MEMORANDUM

From:	Tina Cuss Ecology Officer		
Service	WBC Ecology	App No:	250967
Address:	35 Robin Hood Lane, Winnersh, Wokingham, RG41 5ND.		
Proposal:	Submission of details to comply with the following condition of planning consent 222974 dated 12/12/2022. Condition 5, Ground and Building Levels, 6, Landscape Scheme, 7, Protection of Trees, 8, Biodiversity Statements, 9, CEMP, 10, EV Charging.		
Type of Development:			
Site Visit Made:	No

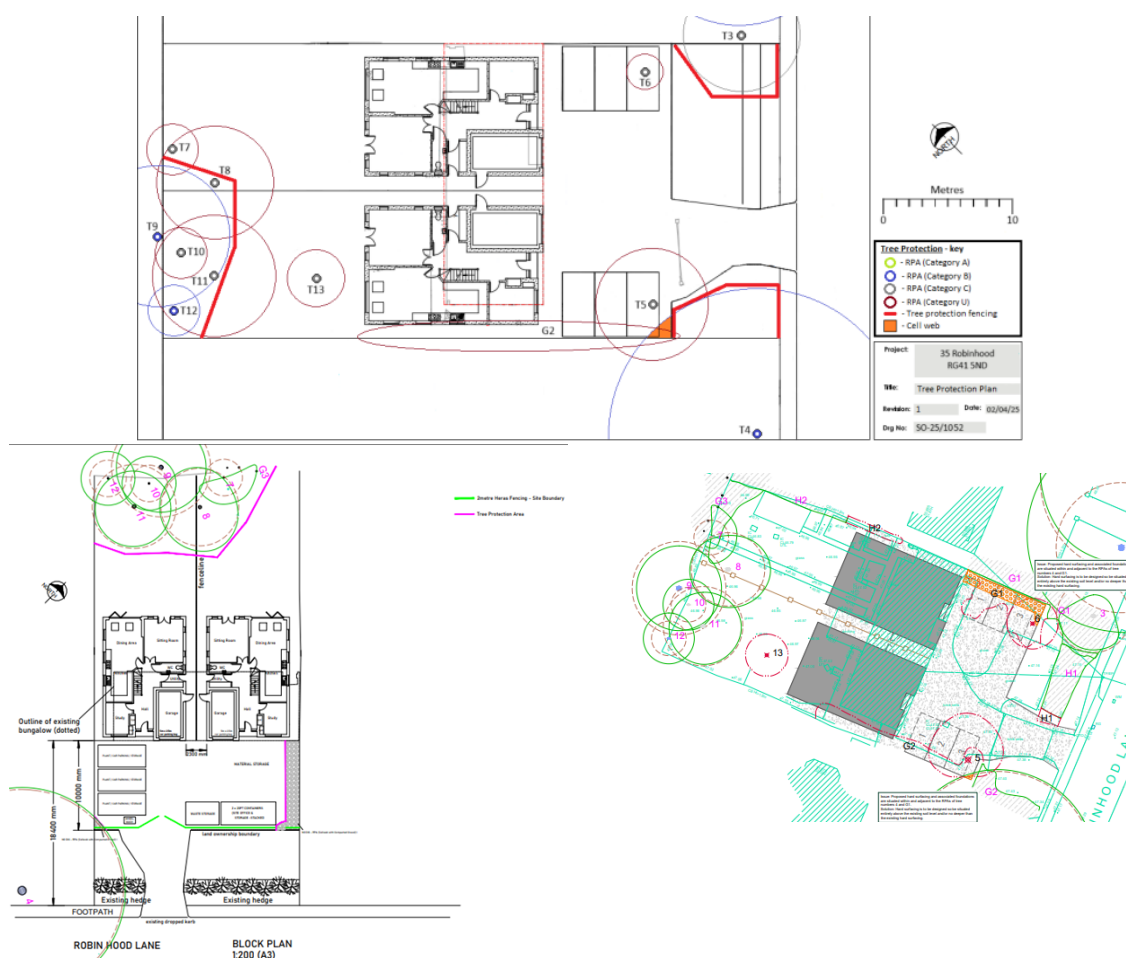
The Block Plan AMS Layout V2 (041022) or AIA Dwg AIA 01 08.07.2022 Block and Location Plans secured the retention of the existing front hedge, G3 and trees T7, T8, T10, T11, T12. The impact on wildlife of the removal of 5 additional trees, western boundary shrubs and the reduction of hedge H1 has not been assessed by the ecologist. The plans approved under and submitted in support of 222974 don't justify additional tree felling and reduction of the hedge and demonstrated that the development could be accommodated without further habitat loss.

Section 6.2.1 and 6.2.2 directly contradicts the Tree Protection Plan on page 12. The net loss of biodiversity diversity habitat and impact on wildlife is not compensated for by the two small trees of unspecified size and species and small area of shrub planting proposed in drawing 931-LA-P-02. I note the CellWeb path proposed in the Block Plan along part of the northeastern section of the front garden to protect G1 in the

neighbour's garden has been omitted by South Oaks Arboriculturist.

I advise that the AMS is not approved and is amended in line with the proposed tree retention and the tree protection fencing and ground protection that were proposed when 222974 was approved.

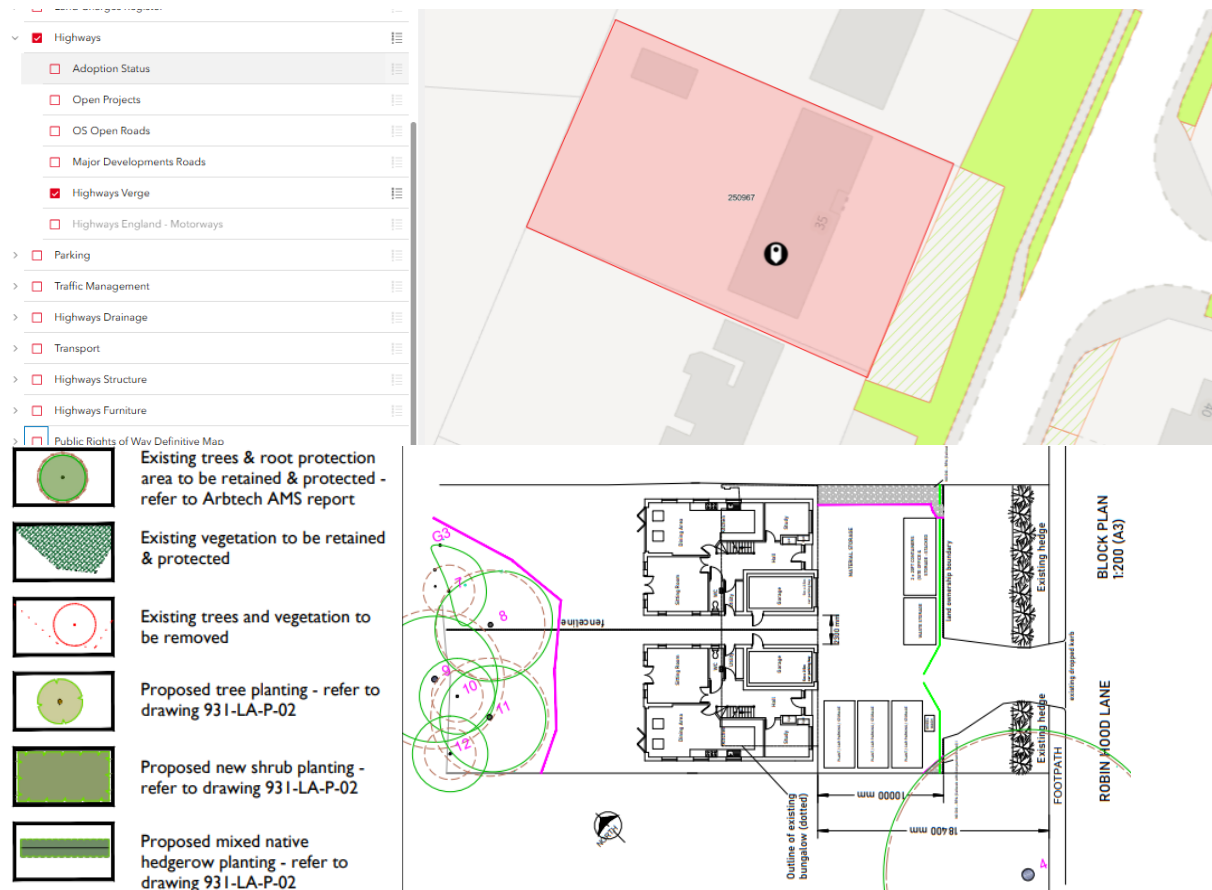
The legend of Dwg 931-LA-P-02 refers multiple time to Dwg 931-LA-P-02 but it appears no details of the species schedules, stock size and density appear to be provided. Dwg 931-LA-P-02 refers to tree protection in accordance with Arbtech Tree Survey & AMS Report and not the Arboricultural Method Statement prepared by South Oaks Arboricultural Consultancy which is currently submitted to discharge condition 7. I note the permanent CellWeb tree ground protection proposed by South Oaks in the RPA of T4 is not included in the Landscape General Arrangement Plan.

To support approval of the Landscape General Arrangement Plan Dwg 931-LA-P-02 trees T8 and T11 and hedge H1 on the adopted verge owned by the Highway

Authority must be retained. In line with CP3m CP7 and MDD TB23, the requirements of condition 6 for replacements for all trees and hedges (including G2 and G3) lost to development must be proposed and must include species, sizes and numbers of shrubs and trees. I note the permanent CellWeb tree ground protection proposed by South Oaks in the RPA of T4 is not included in the Landscape General Arrangement Plan.
